**CITY OF NEW BERLIN
PLAN COMMISSION MEETING
Monday, August 15, 2022**

**CITY OF NEW BERLIN
DEPARTMENT OF COMMUNITY DEVELOPMENT
PLAN COMMISSION STAFF REPORT**

**Emily Petrie with Kohler Pit/ Kohler Pit On-going Filling and Interim Grading Plan
4635 S. Racine Avenue (Tax Key #: 1231992)**

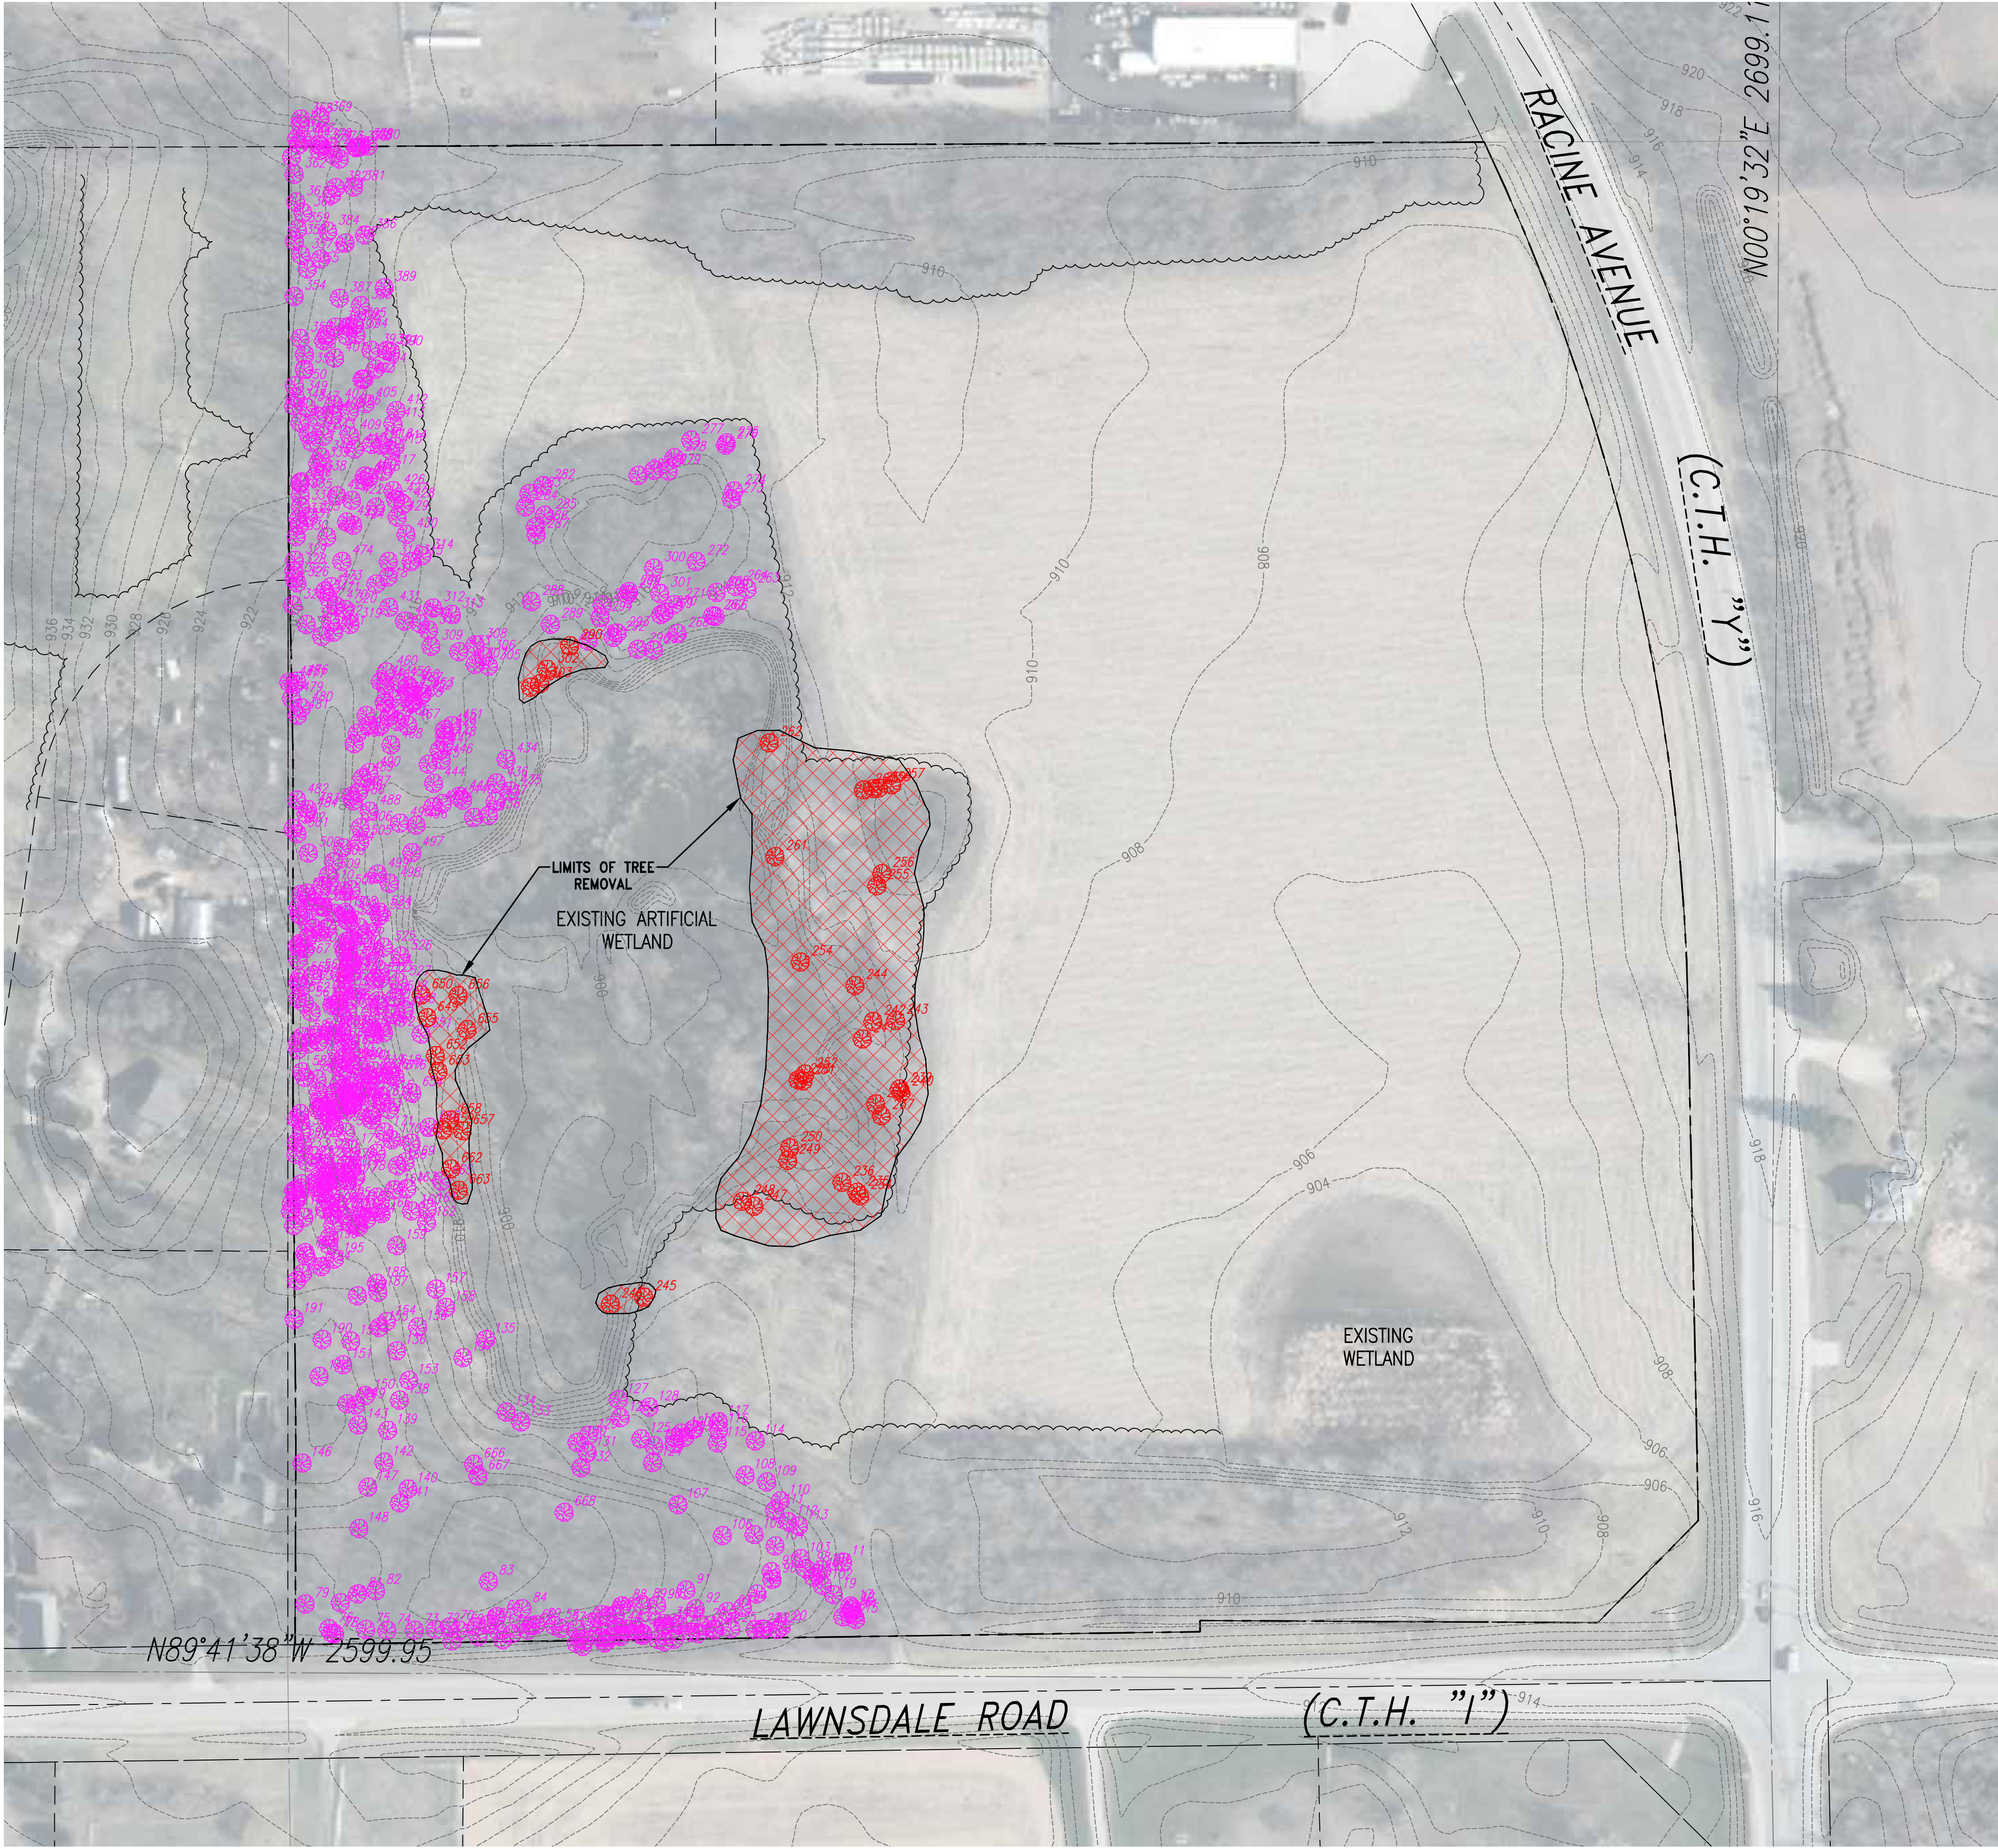
- d. Sheet C1.2:
 - i. Construction Sequence Plan:
 - 1. Phase 1: #8. Remove the word 'Note' from the end of this sentence.
 - 2. Phase 2: #15. Remove the word 'Note' from the end of this sentence.

- 3. #14 Change this note to say: Begin mass grading of the site. Mass grading may only occur/continue AFTER erosion control measures are installed/constructed (Silt Trap, Swales, Ditch Checks, Etc.) and Phase I is complete and stabilized.

- 4. Phase 3: #19. Change 'phase 2' to 'phase 3'
 - 5. #21 Change this note to say: Begin mass grading of the site. Mass grading may only occur/continue AFTER erosion control measures are installed/constructed (Silt trap, Swales, Ditch Checks, Etc.) and Phase II is complete and stabilized.

- 6. #22 Change 'Phase 2' to 'Phase 3' and remove the word 'Note'.
 - 7. #23 Change 'Phase 2' to 'Phase 3'.
 - 8. #26.2 Change 'Village' to 'City'.

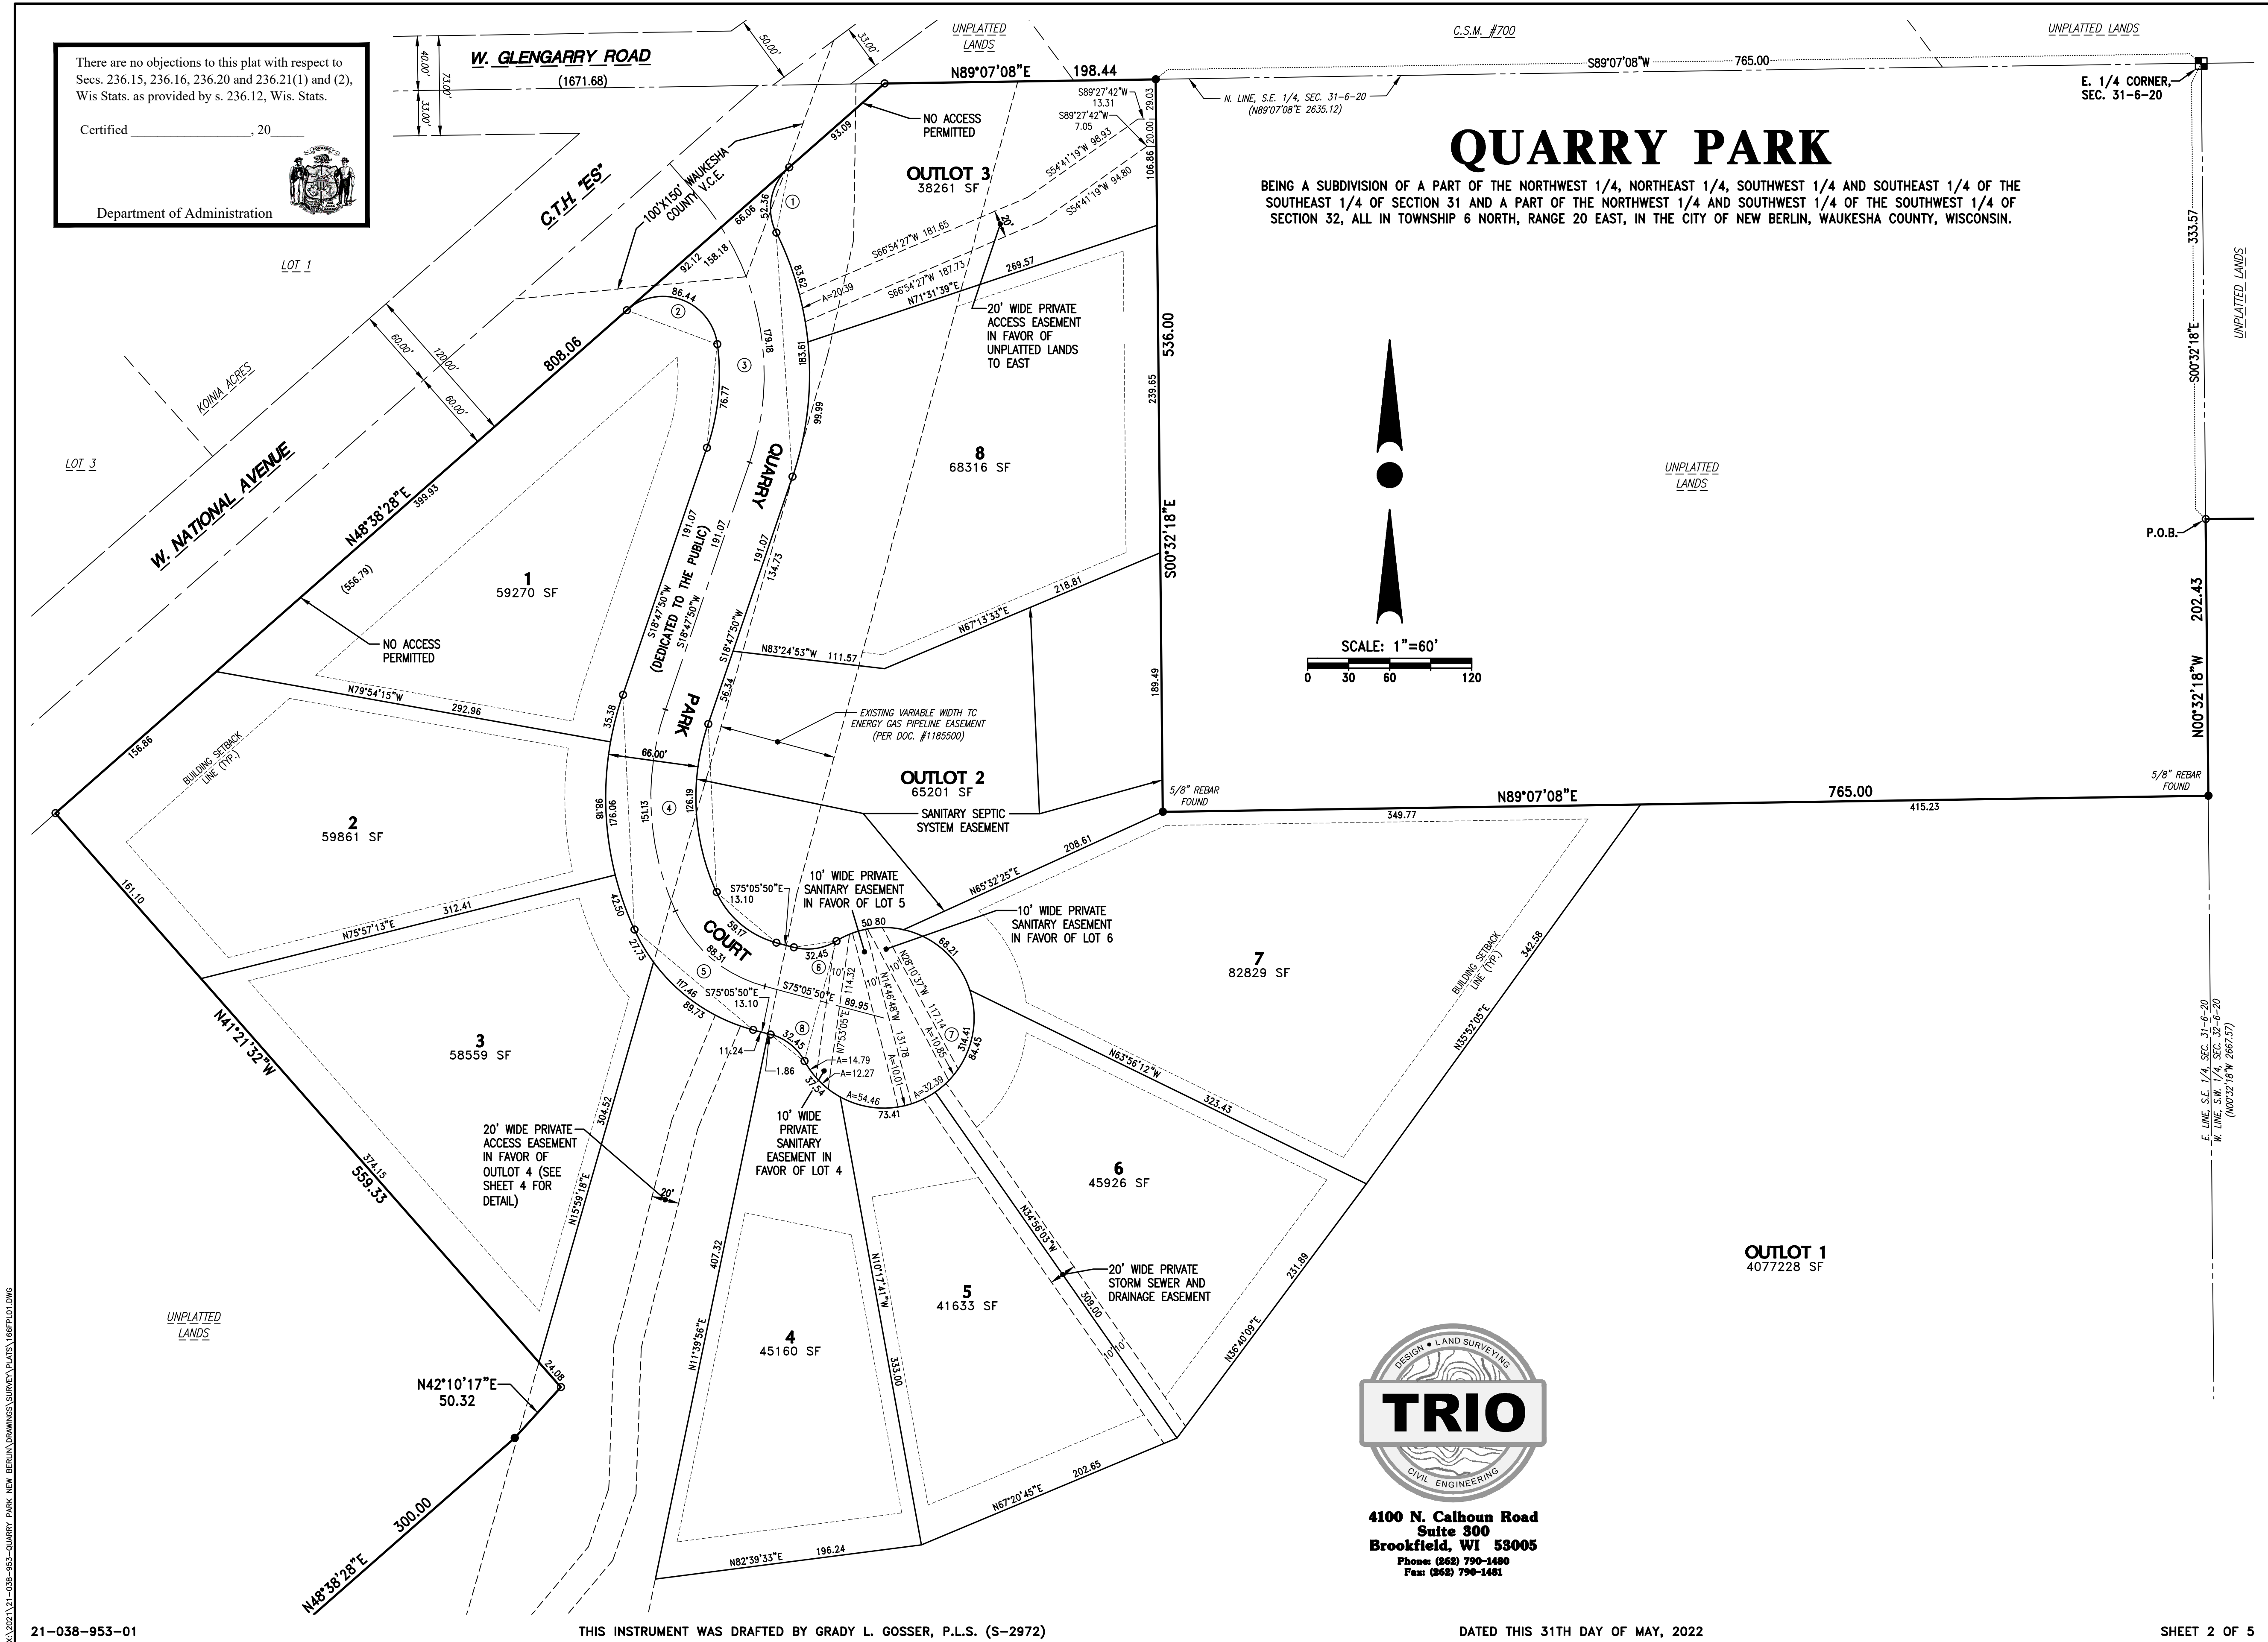
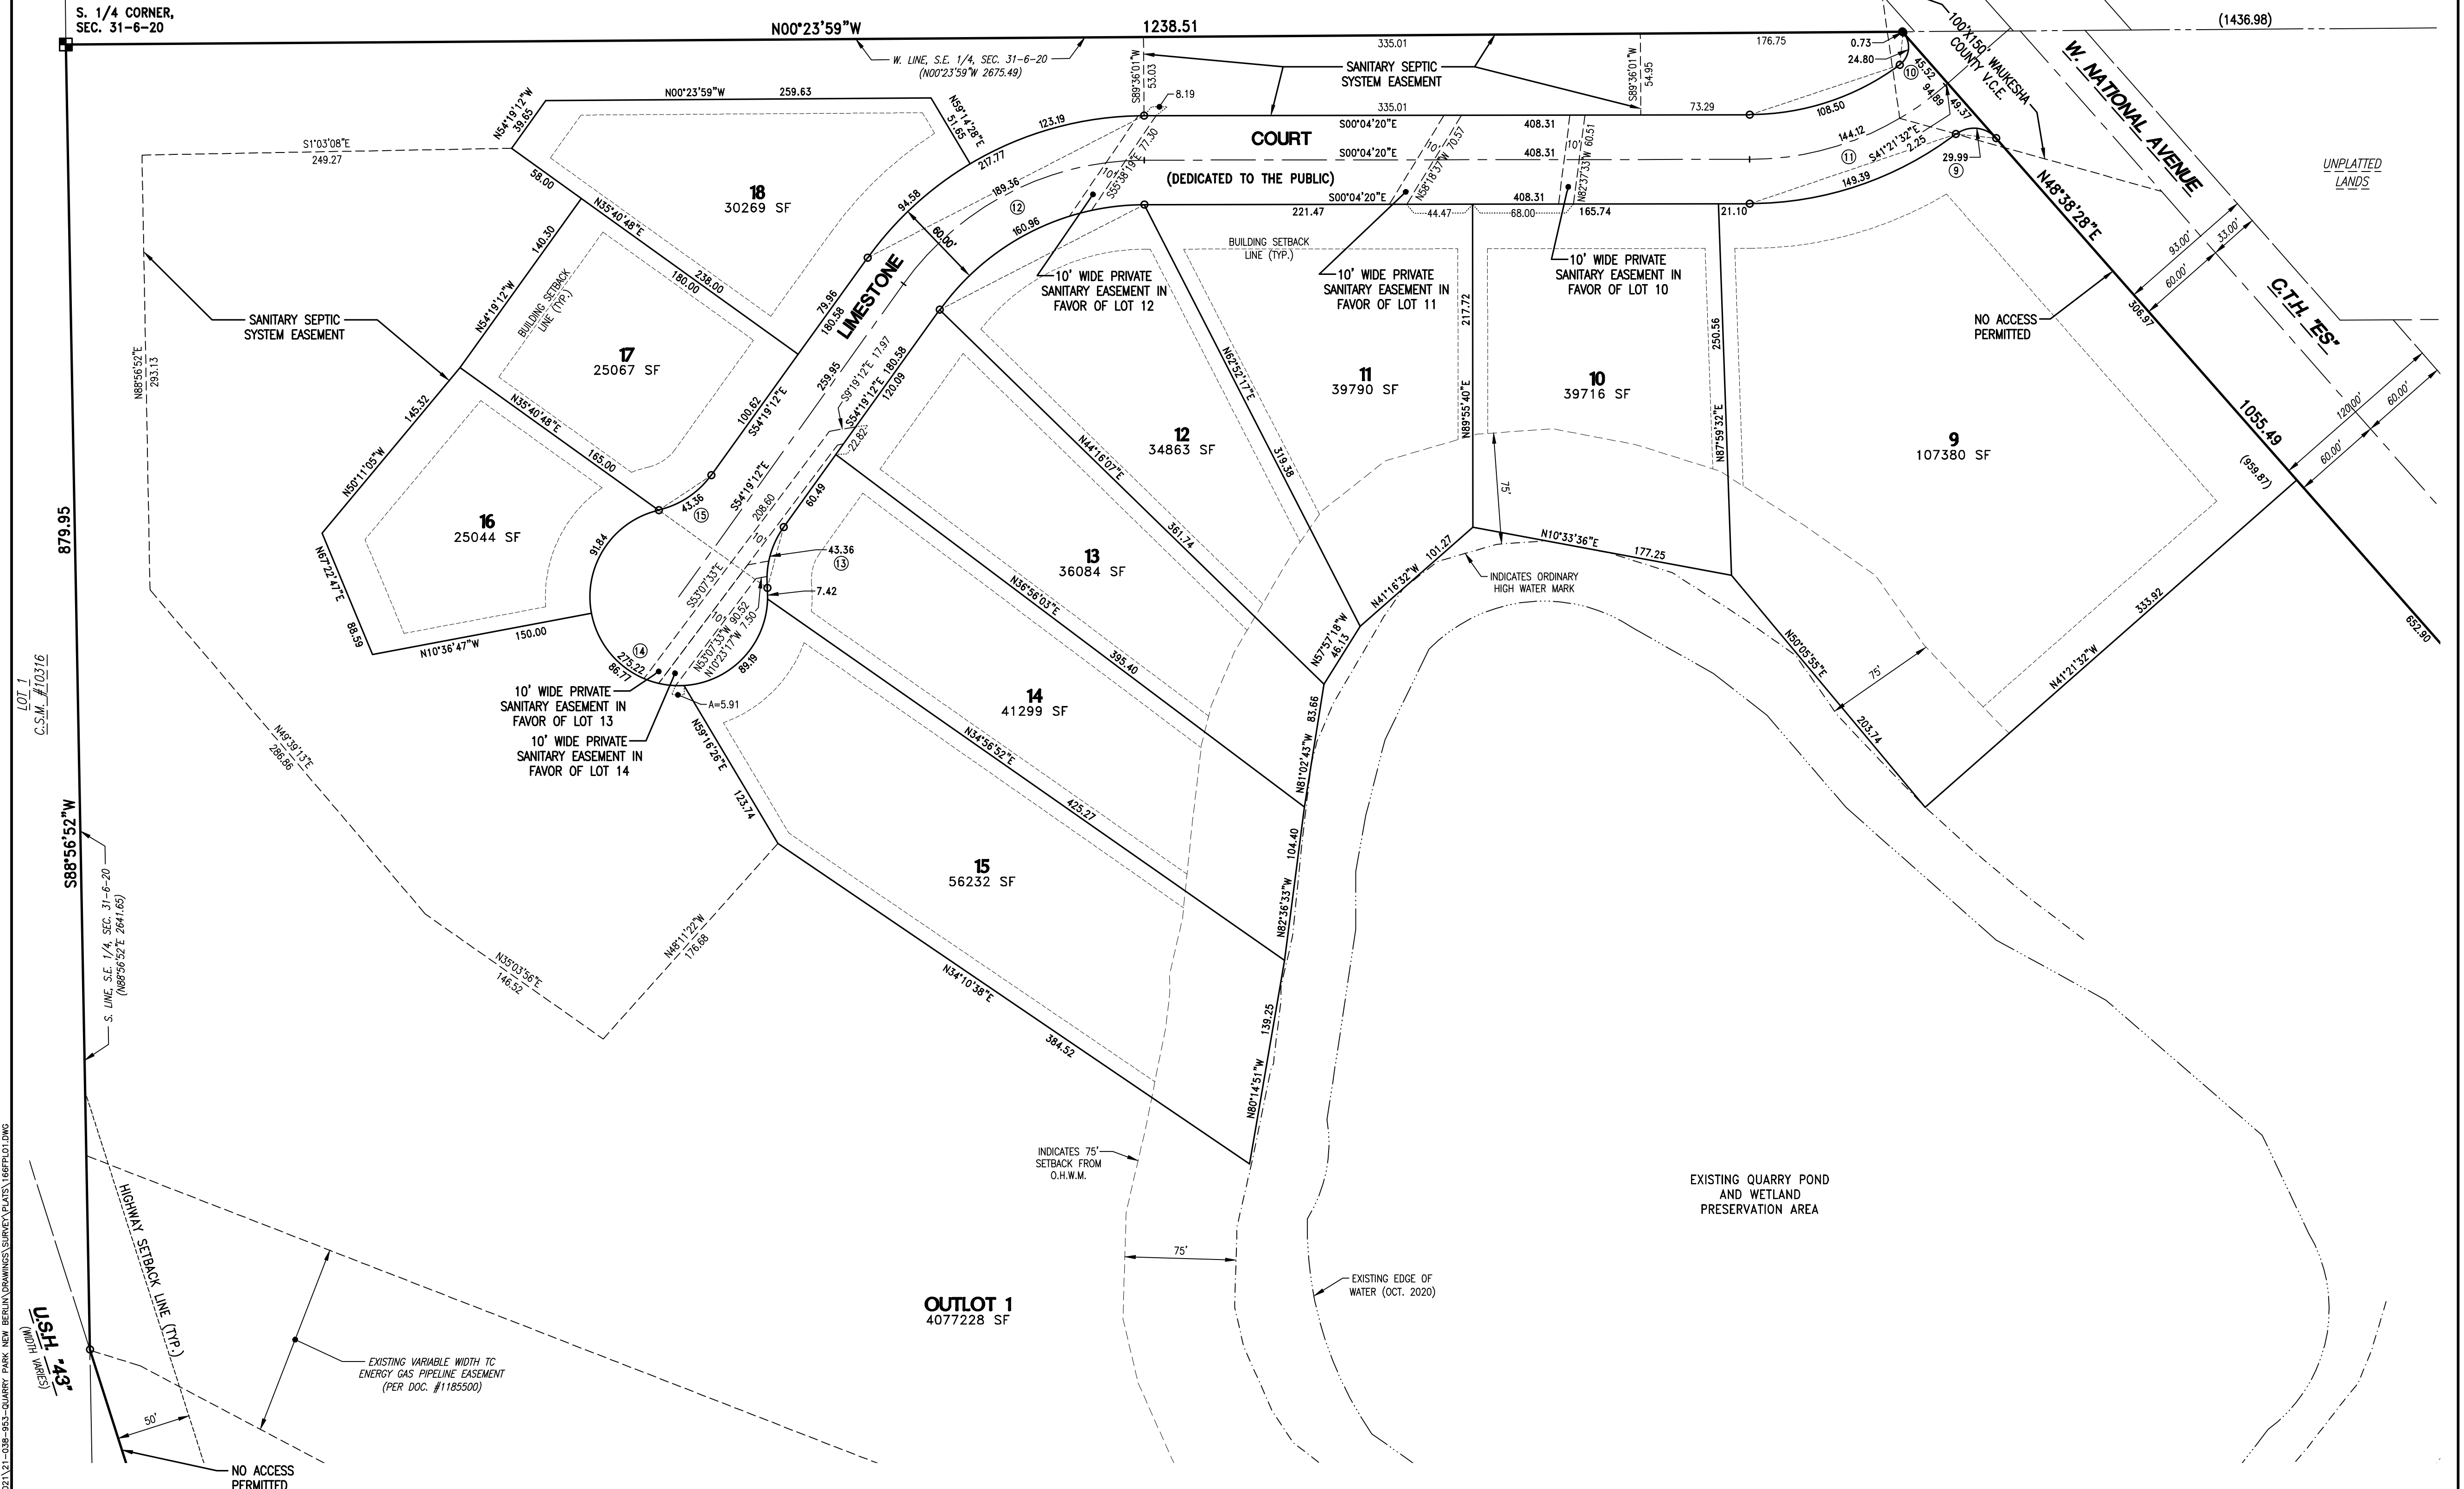
- e. Easements are not allowed in the City ROW. Recommend renaming to "Location of Private Sanitary Lateral" in favor of Lot X throughout the plat specifically on the call outs on sheet 2 and 3.
